4.0 DESIGN DEVELOPMENT

4.9 RESPONSE TO PLANNING FEEDBACK

HOPWOOD HALL COLLEGE, MIDDLETON CAMPUS, ROCHDALE ROAD, MIDDLETON, M24 6XH
Application Nos 24/00548/LBC & 24/00547/FUL

PROPOSED PLAN

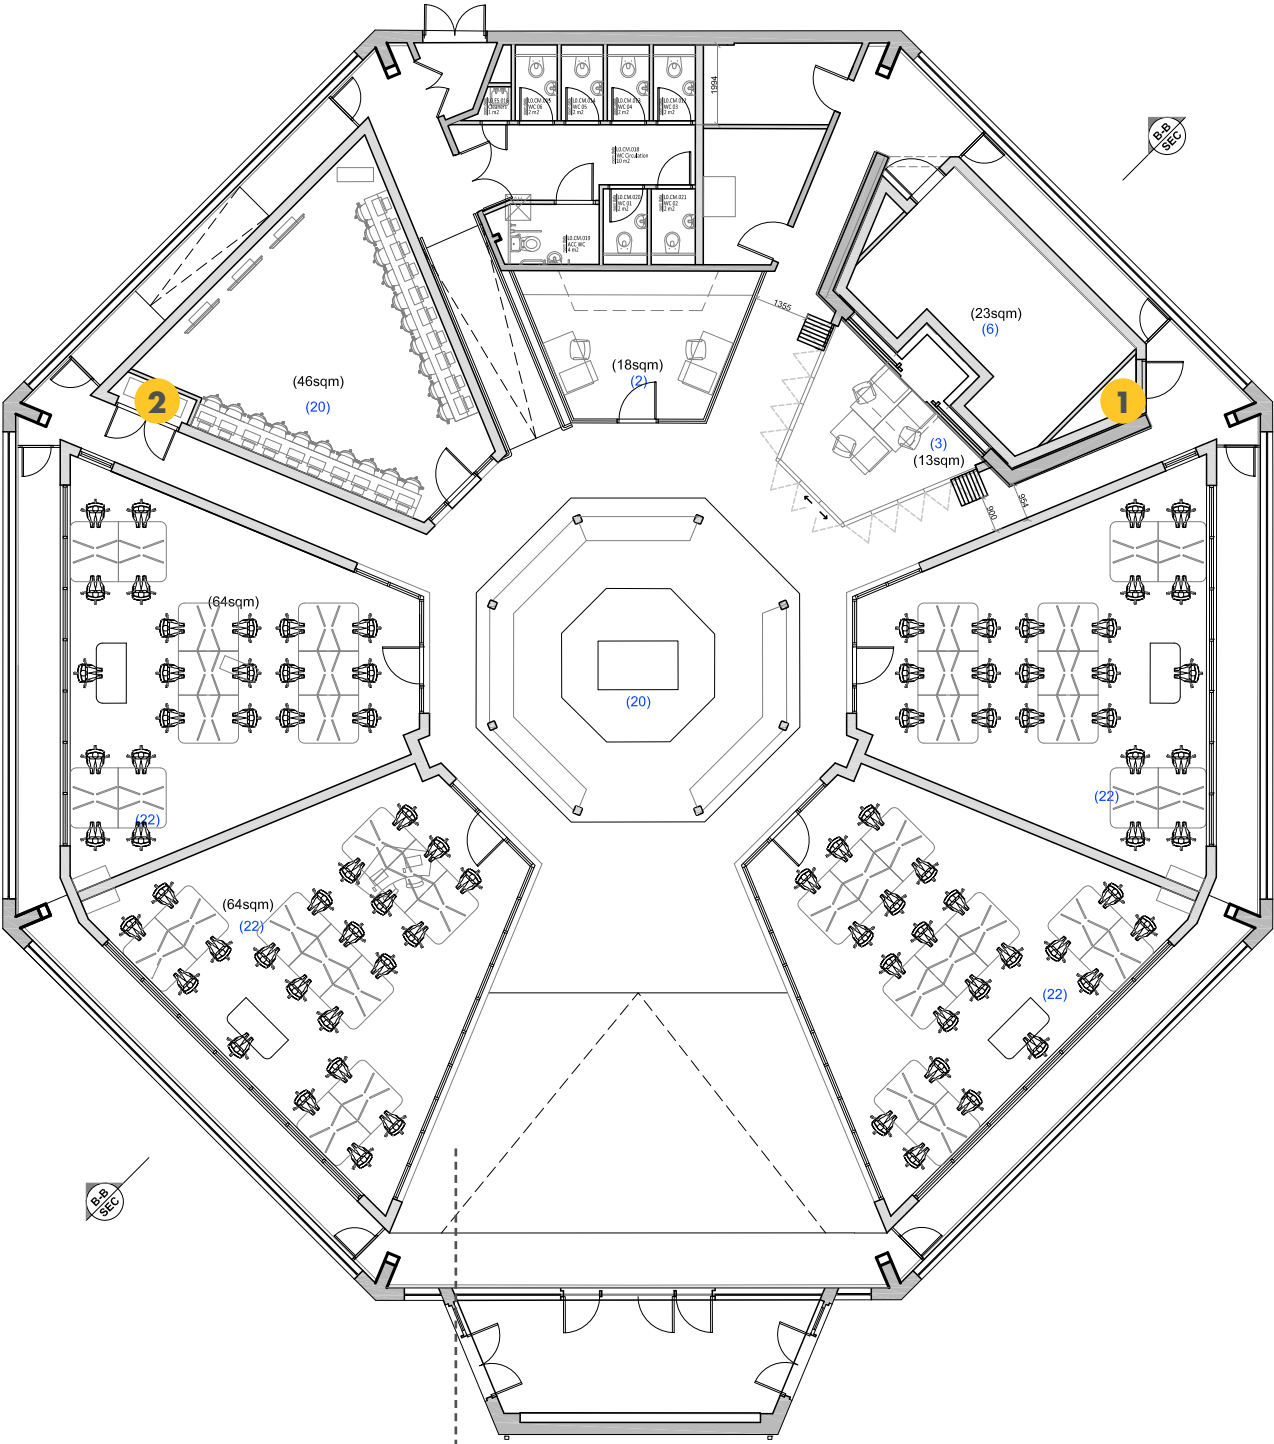
We would encourage the removal or reduction in size of classroom pods to either side of the main entrance to the chapel, to give a greater impression of the volume of the space and to prevent the sanctuary from becoming enclosed. The use of high-quality materials and finishes, with design drawing on the geometric shapes will be vital in sustaining the significance of the listed building.

Consideration has been given to the removal of the two pods to either side of the entrance as requested.

The new stores proposed adjoining the classroom pods either side of the entrance have been shown as re-positioned to help to open up the space as much as possible upon entering the Chapel.

- 1 Cleaner Store relocated
- 2 Laptop Store relocated

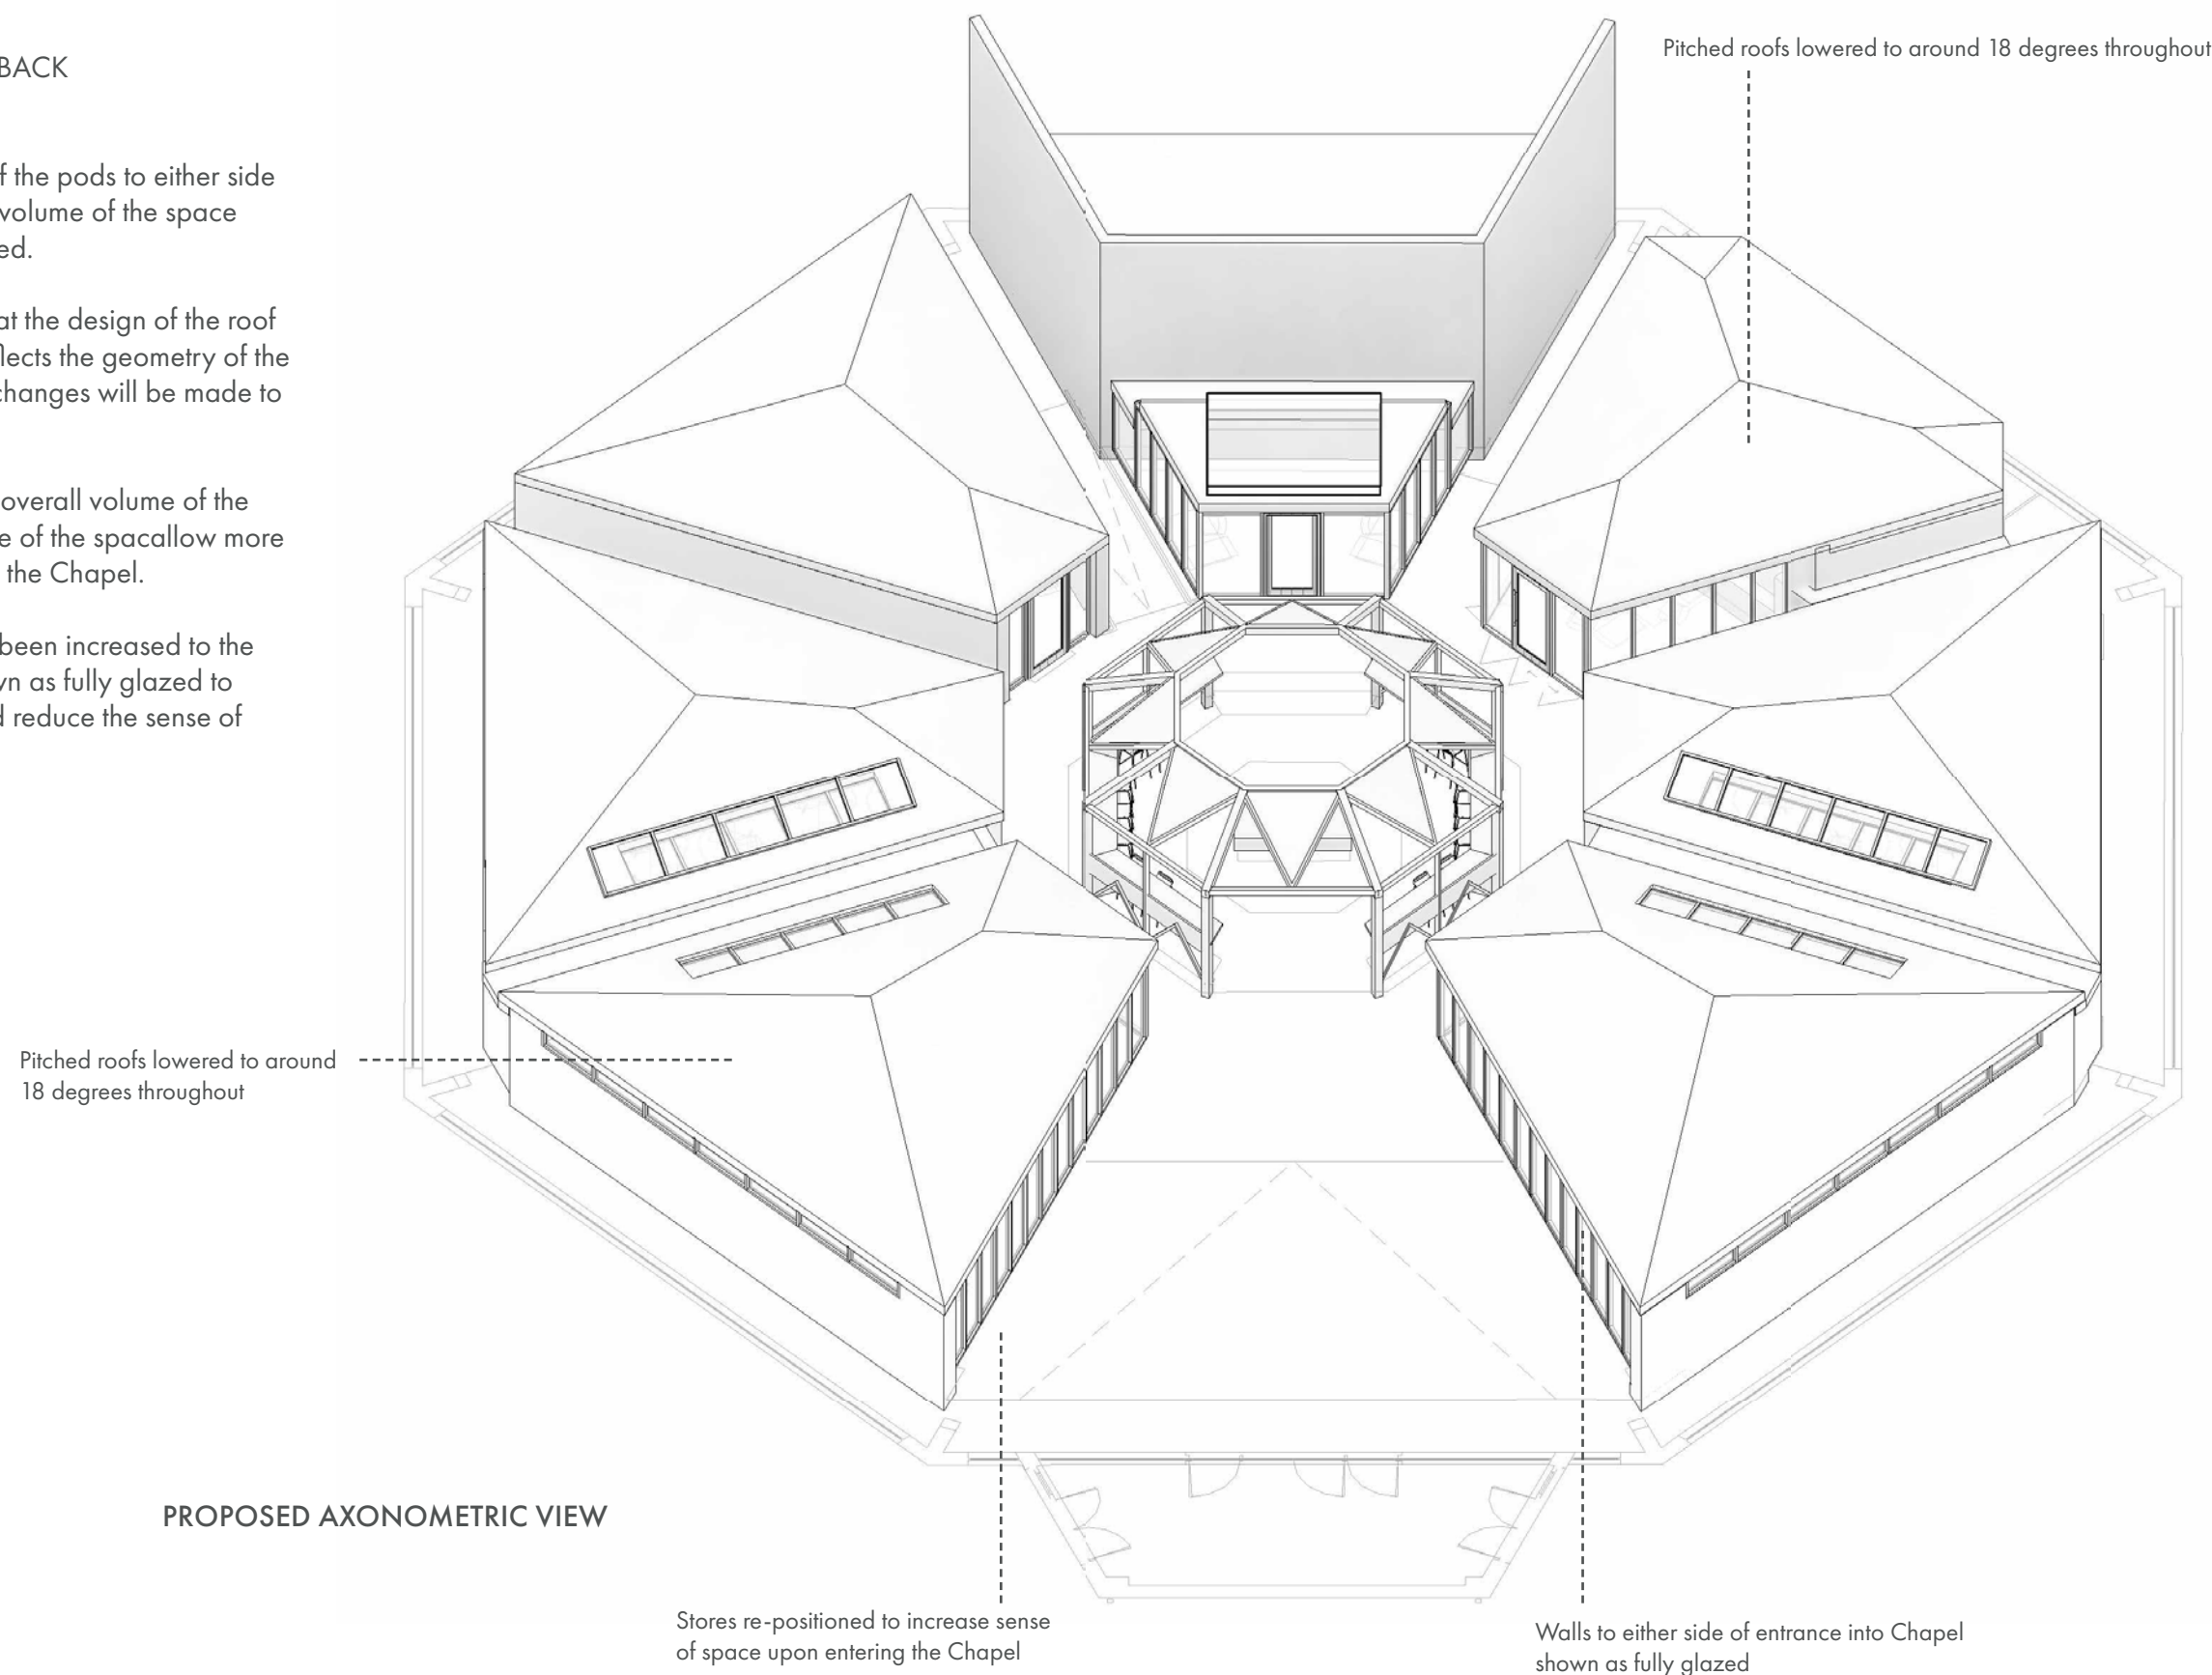
Further consideration has been given to the design of the pods to either side of the entrance, to allow a greater impression of the volume of the space and to prevent the sanctuary from feeling too enclosed.

Having considered several options, it is proposed that the design of the roof remains as a pitched roof system in order that this reflects the geometry of the existing roofscape. It is proposed that the following changes will be made to the design of the pods:

1. The pitch of the roof is reduced to help reduce the overall volume of the pods and to allow a greater impression of the volume of the space allow more of the original fabric to be visible upon entrance into the Chapel.
2. The amount of glazing to the classrooms has also been increased to the walls either side of the entrance. These are now shown as fully glazed to help increase the visual permeability of the pods and reduce the sense of enclosure upon entrance into the Chapel.

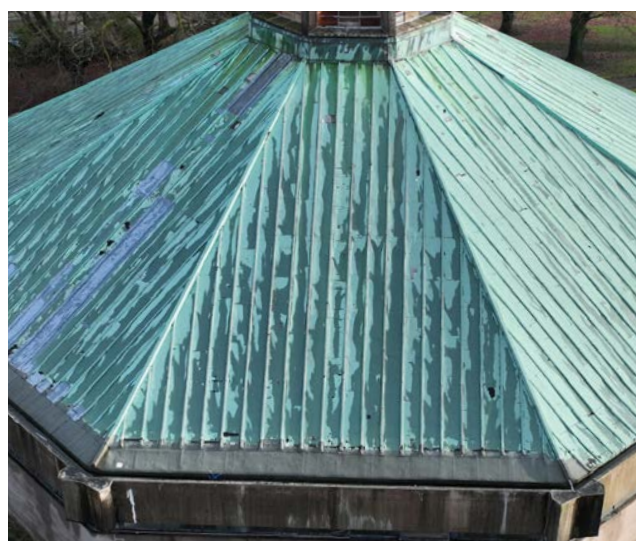
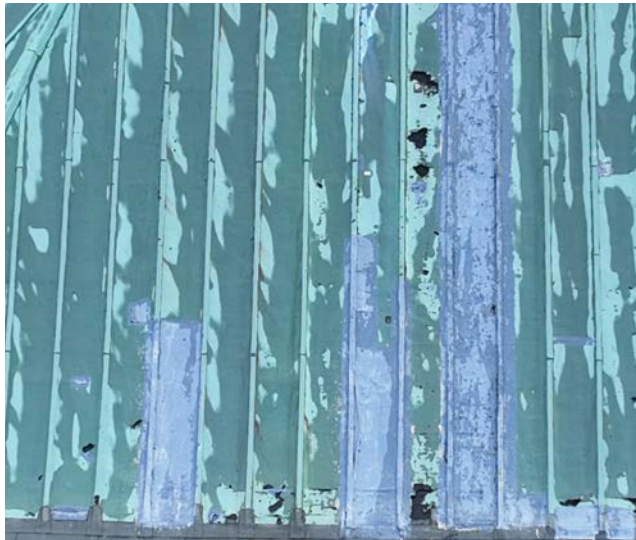
Our preference from a heritage and cost perspective would be to retain and repair the existing copper roof and cladding. However, it is proposed to replace the existing copper roof covering as this is considered to be beyond economic repair.

- *Reviewing the images we think the copper has passed its sell by date and would not be suitable for reuse.*
- *There are a number of failures and repairs over the sheets and this would indicate there would be little benefit in trying to save some sheets.*

- *Looking at the photo's there are dozens of patches all over the roof and there are also large areas that have been coated with liquid roofing products.*

- *This indicates to me that the copper is split in many places and has reached the end of its serviceable life. I can't see the laps so the copper may have been installed in far too long lengths and if I had to hazard a guess, I would saying the fixing method utilised does not allow for expansion.*

Consideration has been given to the retention of the existing copper and overlaying this using a new copper roof in order that the historic fabric is preserved. However, it is felt that the retention of the copper in it's current condition could potentially cover up ongoing issues with moisture ingress which would be detrimental to the building fabric going forwards.

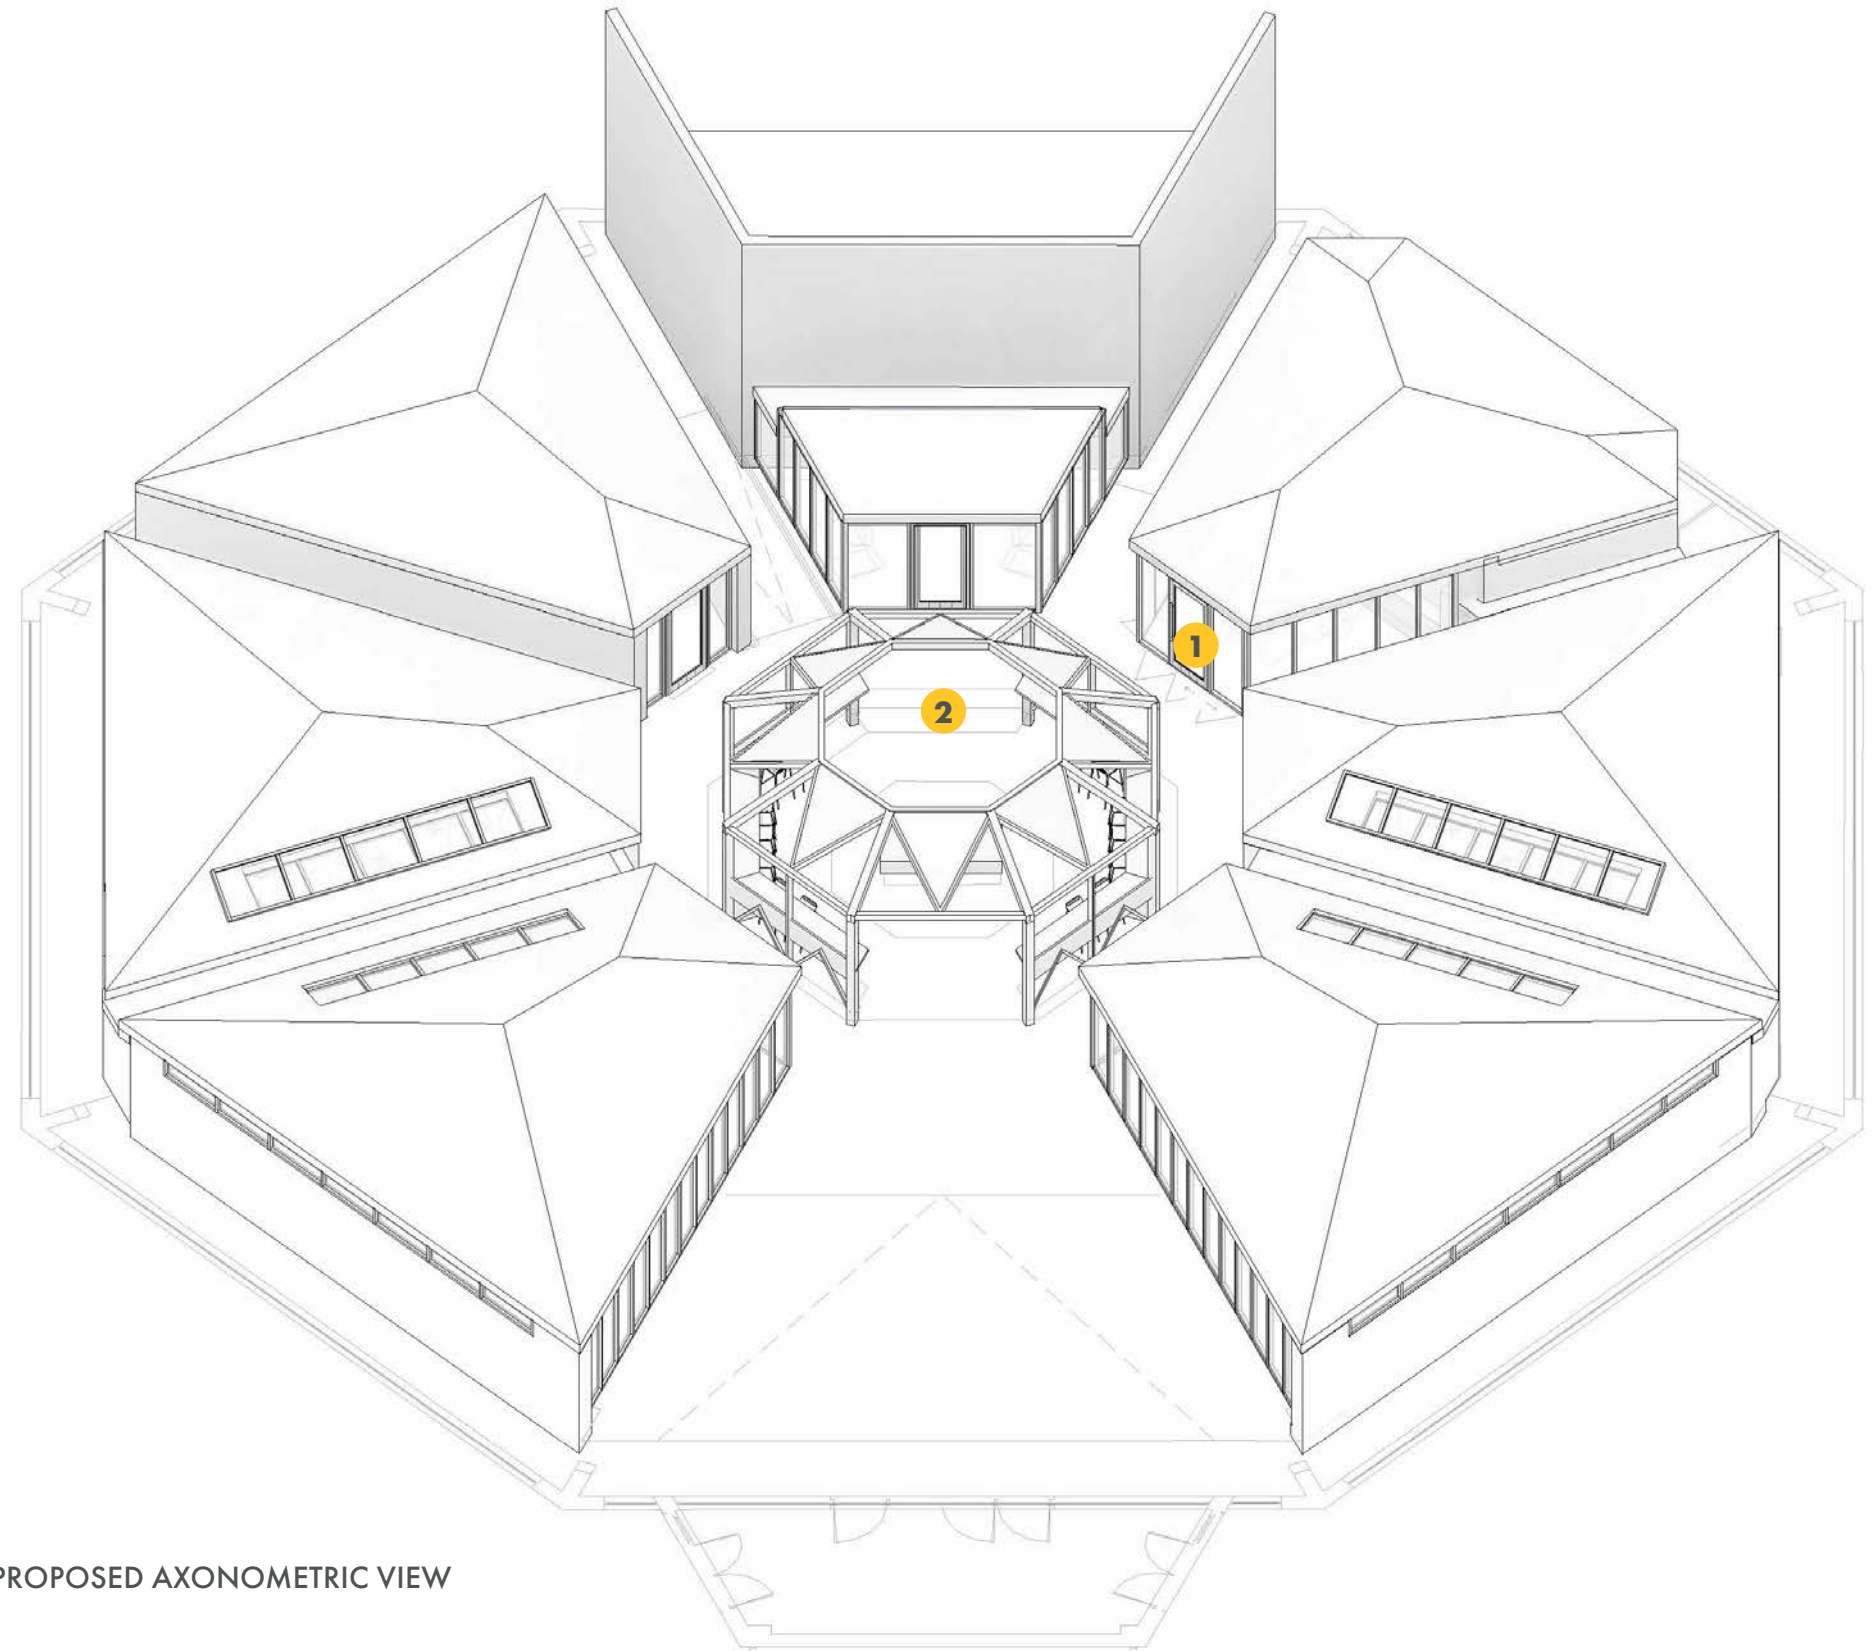
We do however have concerns about proposals to enclose the Blessed Sacrament chapel to create an immersive VR space and staff office. We feel that this chapel should be left unenclosed and remain

It is therefore proposed that this pod is retained but that the design is amended to increase views towards the Blessed Sacrament Chapel and to help preserve the relationship between this and the central altar. The following amendments are proposed:

1. Glazed walls to the office pod are amended to bi-folding doors system to allow these to be fully opened up to minimise the enclosure of the altar and canopy.

2. Sanctuary area amended to re-position the entrance into the Sanctuary area to sit opposite the side chapel - helping to reinforce the historic relationship between the central Altar and the Blessed Sacrament Chapel.
